Office Action Summary

10/700,139

This is the first office action for application number 10/700,139, Tube Retainer, filed on November 3, 2003.

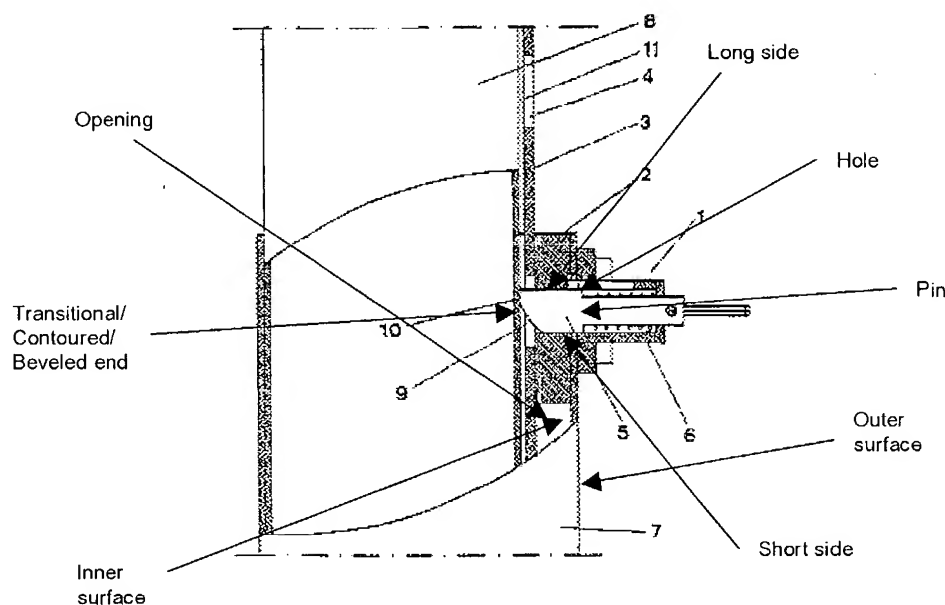
Claims 1, 8 and 9 are rejected under 35 U.S.C. 102(b) as being anticipated by U.S. Patent number 6,398,445 to Matali Badia.

Matali Badia '445 discloses a retainer (above) comprising a cylindrical housing (7, see curved section lines above, further, column 1, lines 14-15 state that traditional systems utilize "tubes" which are defined in Merriam Webster's Collegiate Dictionary - 10th Edition as "any of various... cylindrical structures or devices..."), with an outer surface (above) and an opening (above) through it that is concentrically located in the

housing, the opening having an inner surface (above) and further having at least one hole (above) extending radially from the inner surface to the outer surface, a pin (above) having a top surface (above) and short and long sides (above), the pin being mounted to slide in the hole, the pin further having a transitional end (above) between the long side and the short side, the transitional end extending beyond the inner surface into the opening, and means (6) for forcing the pin toward the opening, wherein the transitional end is a beveled/contoured end.

FIG. 2

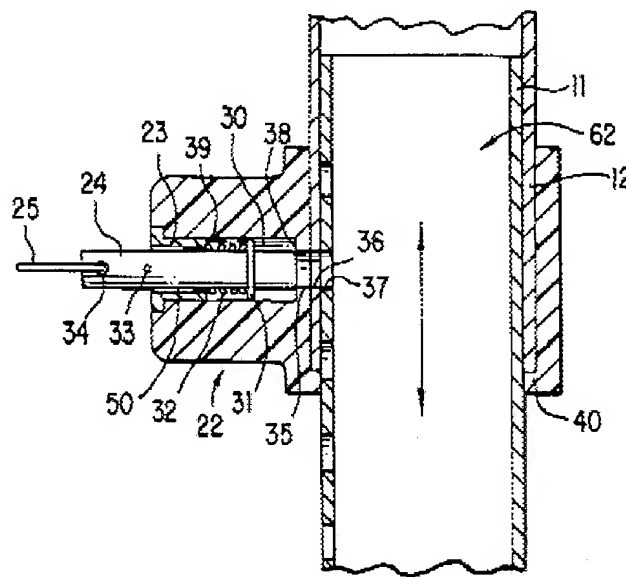
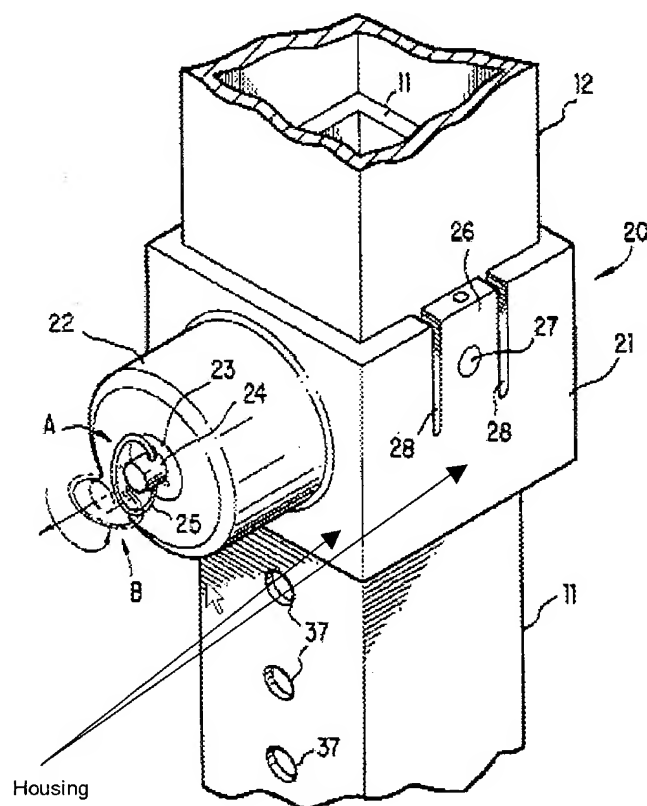
Claims 1, 2 and 4 are rejected under 35 U.S.C. 102(e) as being anticipated by U.S. Patent number 6,575,656 to Suh.

Suh '656 discloses a retainer (above) comprising a cylindrical housing (above, see column 4, lines 36, "circular"), with an outer surface (above) and an opening (above) through it that is concentrically located in the housing, the opening having an inner surface (above) and further having at least one hole (above) extending radially from the inner surface to the outer surface, a pin (above) having a top surface (above) and short and long sides (above), the pin being mounted to slide in the hole, the pin further having a transitional end (above) between the long side and the short side, the transitional end extending beyond the inner surface into the opening, and means (6) for forcing the pin toward the opening, wherein the hole has an upper section (above) with a cross-sectional area and a lower section (above) with a cross-sectional area smaller

that that of the upper section, wherein the cylindrical housing has a groove (above) located about the outer surface.
